**Southern Pines Waterworks Dam Siphon
Town of Southern Pines, NC**

ADDENDUM NO. 3

March 16, 2026

Freese and Nichols, Inc
North Carolina Registered Firm C-3916

SHEET C-2 – Proposed Plan and Profile

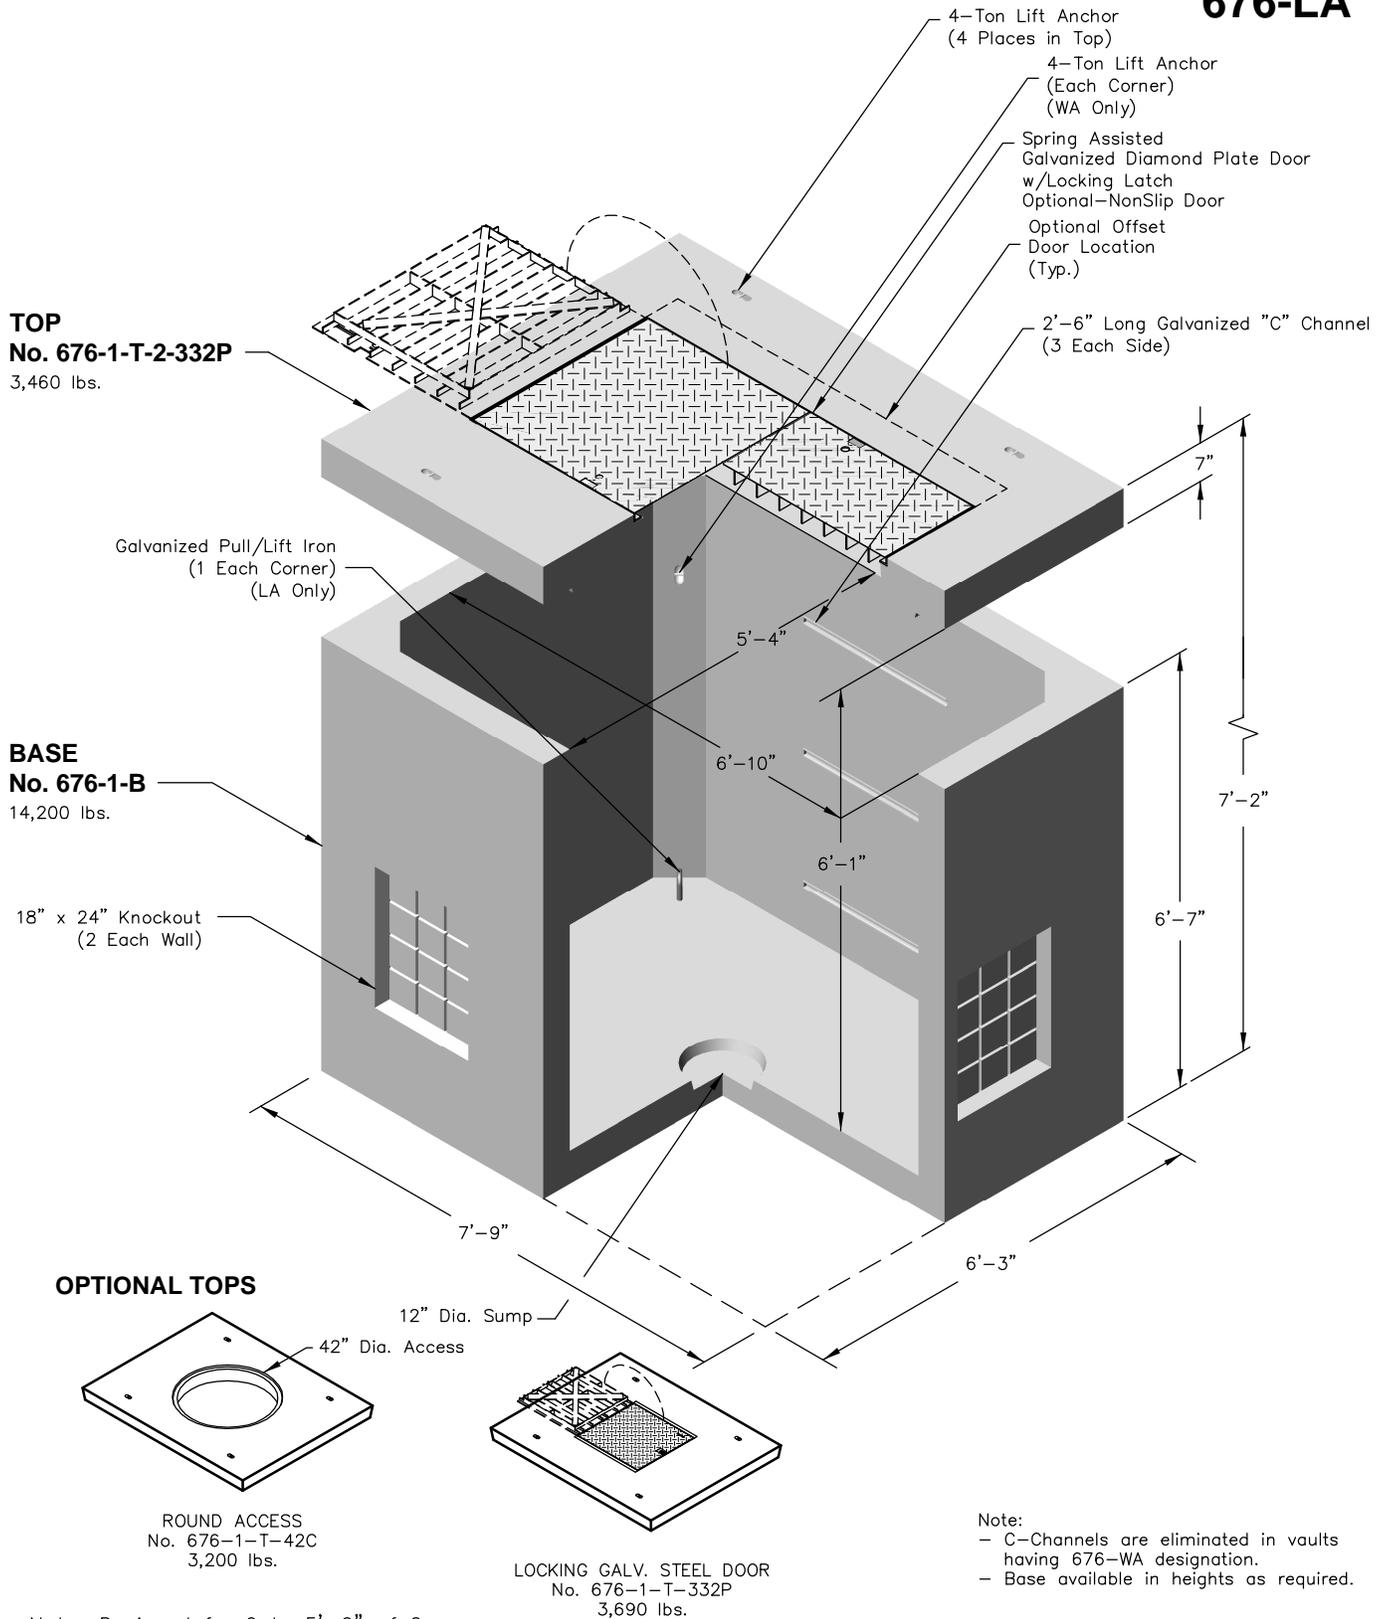
1. Sheet C-2 has been revised to show pipe sizes. Contractor to field verify.
 2. Sheet C-2 has been revised to clarify the two pipes to be grouted. The pipes are intended to be grouted from the downstream toe of the dam to the existing intake structure. The unit-price bid item shall be applied to the separate pipe systems as generally indicated on the drawings.

4. Sheet C-3 has been revised to show the full routing intended to be grouted. Pavement removal and special backfill requirements are not anticipated.

Replace Sheet C-2 in its entirety with the updated Sheet C-2 included in this Addendum.

1 VALVE BOX
1" = 2"

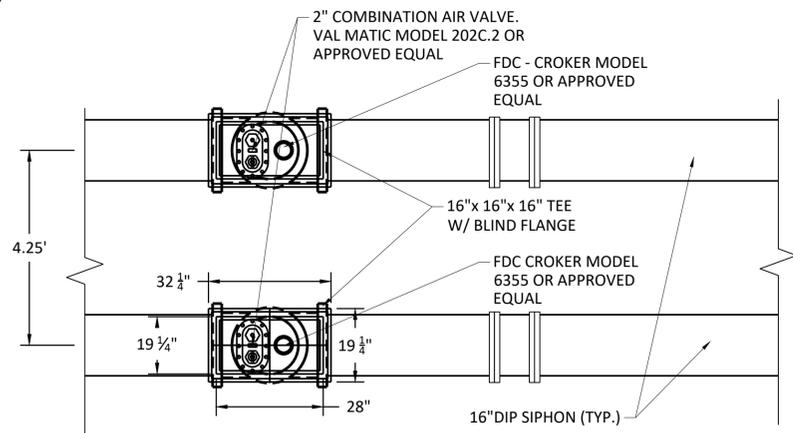
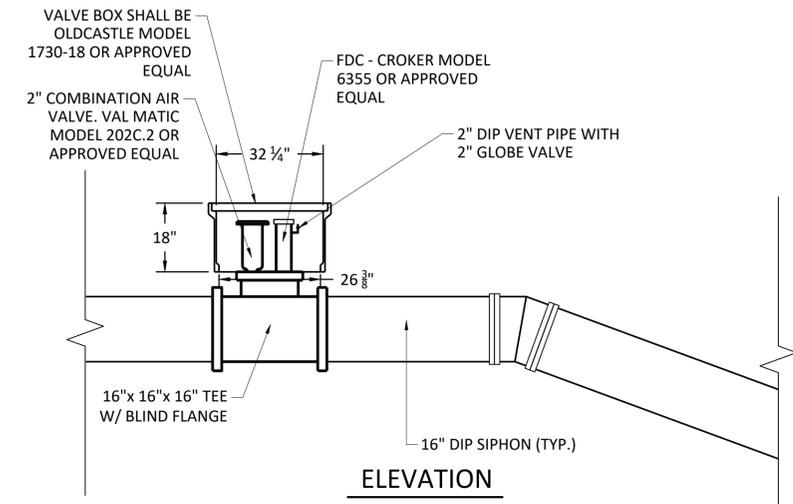
12. **Question:** Please provide the specification for the valve boxes, including the required type, size, material, and load rating (traffic or non-traffic). We are unable to locate sufficient information in the bid documents to properly select and price the required valve box assemblies.

Response: Valve boxes shall be Oldcastle Model 1730-18 as shown on sheet C-3 and shall be traffic rated.

2 VALVE VAULT
1" = 2"

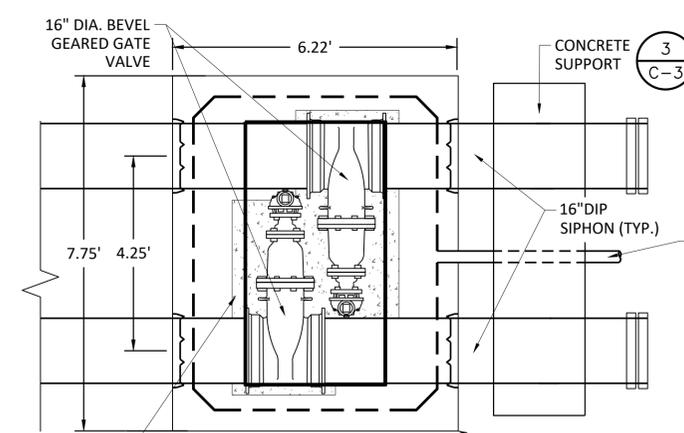
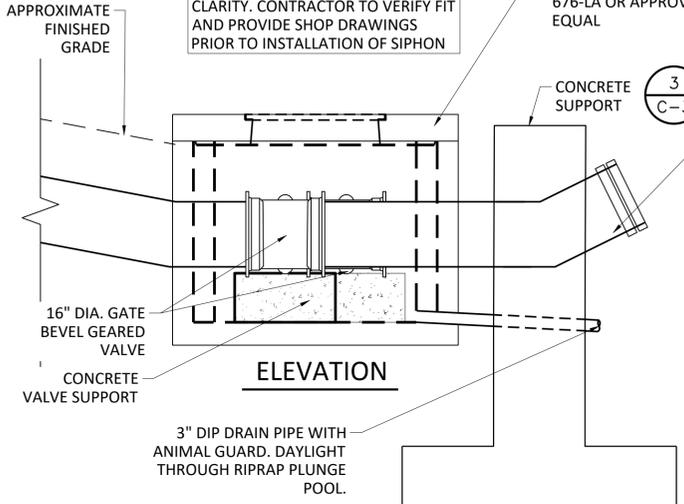
4. **Question:** Oldcastle has advised that they do not have the forming or capacity to supply the valve boxes and vaults identified on Drawing C-3. Please provide the required dimensional details for these structures based on the Oldcastle model numbers listed so that alternate precast suppliers can provide pricing for equivalent units.

11. **Question:** Please provide the specification for the valve vault ring and cover, including the required size, material, frame and cover type, and load rating (e.g., H-20 or equivalent). We are unable to locate this information in the bid documents and need it to properly select and price the appropriate ring and cover assembly.

Response: Dimensions shall be equivalent to Oldcastle Model 676-LA. Model cutsheet is attached to this Addendum for reference.

Response: Valve vault cover shall be Oldcastle Model No 676-1-T-332P or equivalent.

4 SIPHON INTAKE
1" = 2"

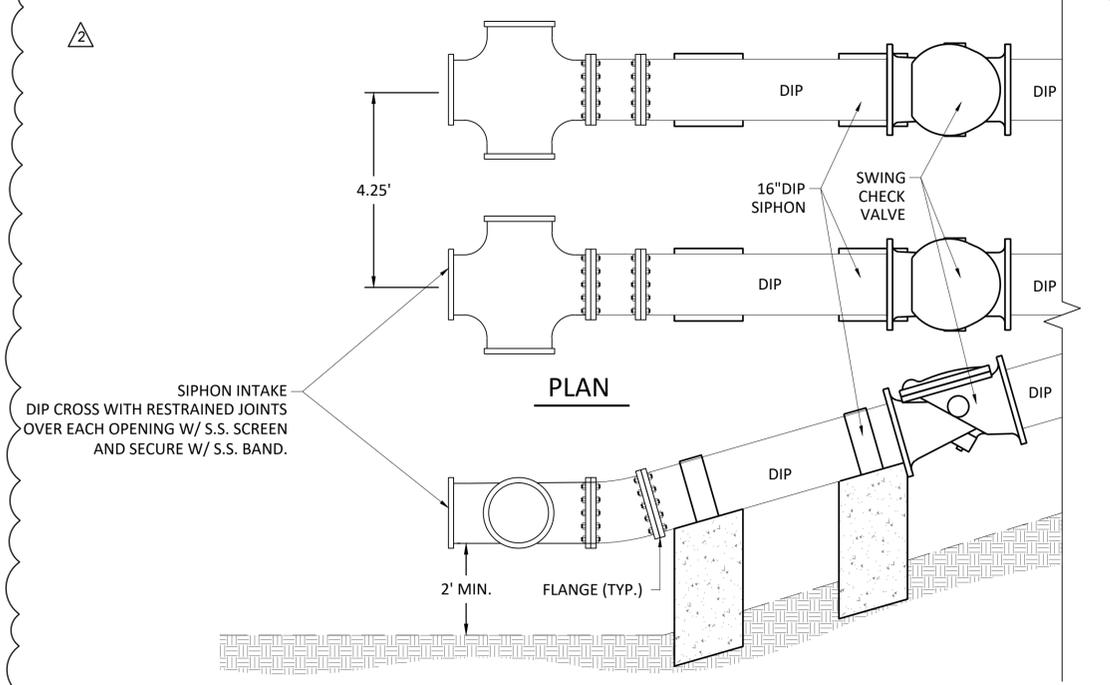
7. **Question:** Detail 4 on Drawing C-3 shows a dark rectangular shape near the end of the intake section, just before the perforated portion of the PVC pipe begins. This appears to indicate a pipe strap with a foundation beneath it; however, the elevation view in this detail does not clearly show a foundation, and a corresponding foundation is not shown in the profile view on Drawing C-2.

Please clarify what this element represents and confirm whether a foundation or support is required at this location, or if this is a drafting error.

10. **Question:** Please provide the specification for the 16-inch PVC intake pipe so bidders can properly determine and price the required pipe material, pressure class/DR, perforation requirements, joint type, couplings, and any required restraints or fittings. The current bid documents identify a 16-inch perforated PVC intake with coupling, but do not appear to provide sufficient detail to determine the exact pipe type and rating required for bidding.

Response: The siphon intake has been replaced with a DIP cross with flanged connections. Refer to Sheet C-3 attached to this addendum.

Response: The siphon intake has been replaced with a DIP cross with flanged connections. Refer to sheet C-3 attached to this addendum.
